City of Alexandria, Virginia

MEMORANDUM

SUBJECT: CONCEPT REVIEW OF 2407 POTOMAC AVENUE (2405, 2401, 3701, 3251
POTOMAC AVENUE, 700 CARPENTER ROAD, 1702, 1880 AND 2500
POTOMAC GREENS DRIVE:
METRO SOUTH PAVILION AND BRIDGE EGRESS STAIR
BAR CASE # 2020-00380

WMATA POTOMAC YARD METRORAIL STATION | POTOMAC YARD CONSTRUCTORS JOINT VENTURE - AUGUST 21ST 2020

Figure 7: Plan of Egress Stair

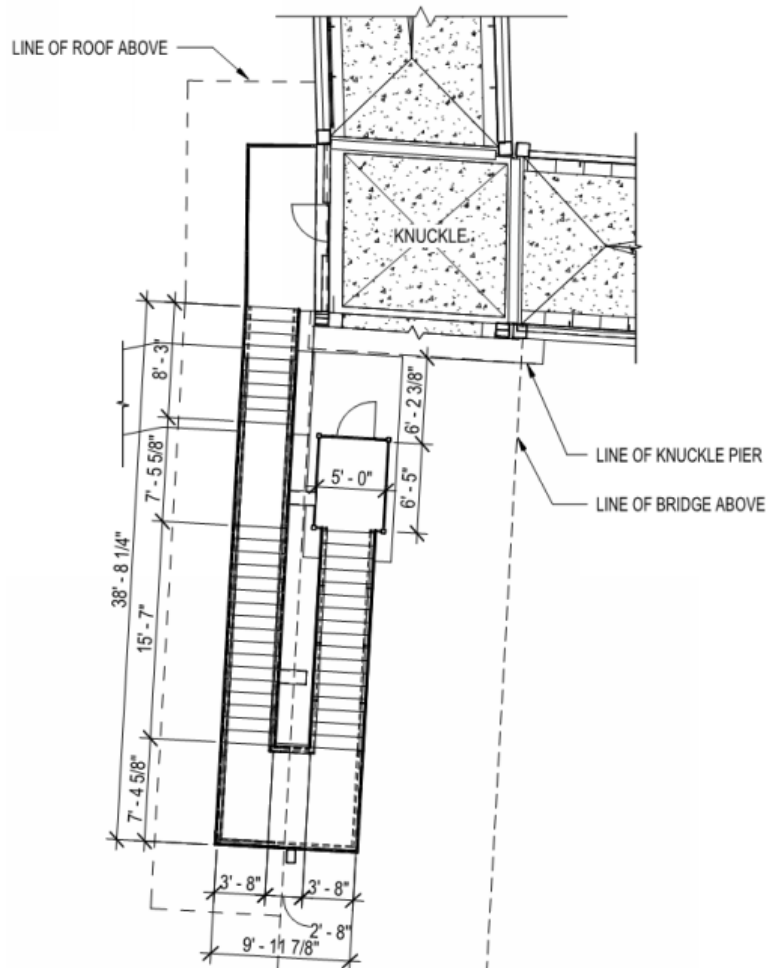
The intention for the design for the egress stair is that by utilizing the same components as the pedestrian bridge, the stair will become less prominent. The layout of the stair does effectively achieve this by turning the third run back so that a major portion of the stair is under the pedestrian bridge. Some portions of the stair do appear bulky in mass and detract from the carefully designed bridge bases.

Figure 9: Comparison of roof at north pavilion (left) and South pavilion (right)

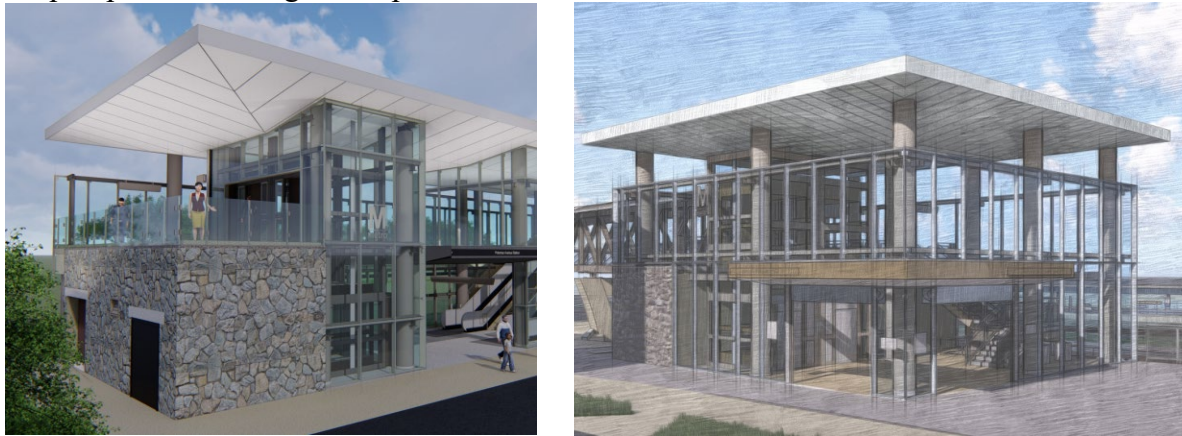
One element that should be studied further is the profile of the roof that floats above the curtainwall. In the design for the south pavilion this element appears to be heavier than it does at the north pavilion. This element is critical to the design of the pavilion because the impression

that the roof form is floating above the structure allows for the curtainwall system to read as an independent element. In the north pavilion the columns are set further inside the perimeter of the building, this is not possible at the south pavilion, but a manipulation of the roof edge condition will help to provide this lighter impression.

Figure 10: North elevation showing mechanical enclosure and double door

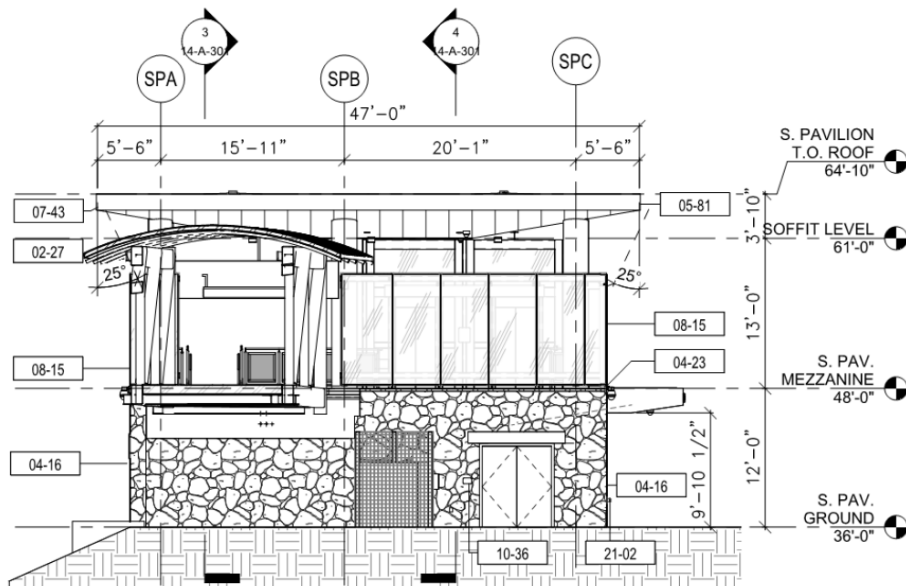
The submitted drawings for the south pavilion show a double door and screen enclosure on the north elevation. The plan indicates that the double door provides access to the service space and that mechanical equipment is contained within the screen enclosure. The design for the building relies on it being a clean cube and these elements disrupt the stone base. The applicant should explore the possibility of relocating these elements underneath the pedestrian bridge where they will be less visible. As shown in the drawings the screen for the mechanical equipment appears to be a fence type of material. Alternate materials for this enclosure should be explored that will be better integrated into the architecture of the pavilion.

Figure 11: Section at entry canopy

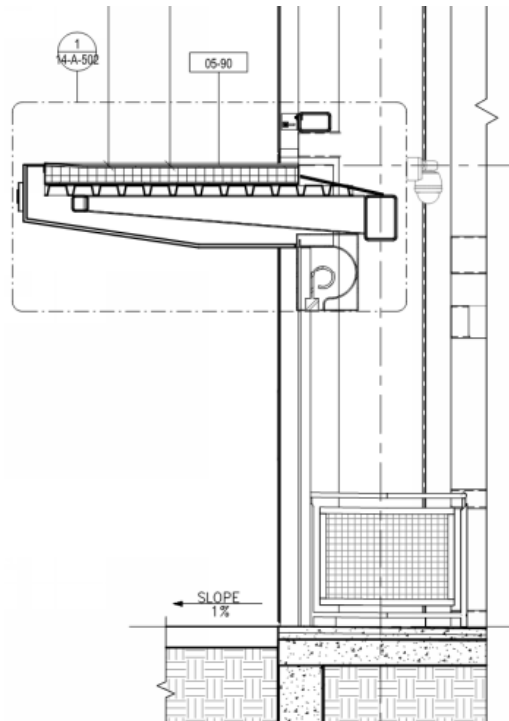
The two sided canopy over the entrance to the pavilion is shown as a metal assembly with space for a signage band along the outside. The roll up door that will be used to close the station during off hours is located at the underside of the canopy. The overall impression of this assembly is heavy and is not compatible with the surrounding curtainwall enclosure. Similar to the profile of the roof, this element should feel slender and elegant so that it appears to float above the opening. This can be accomplished while still accommodating the need for a sign band. Through manipulation of the slope of the underside of the roof and recessing the roll up door the overall visual weight of the canopy will be reduced.
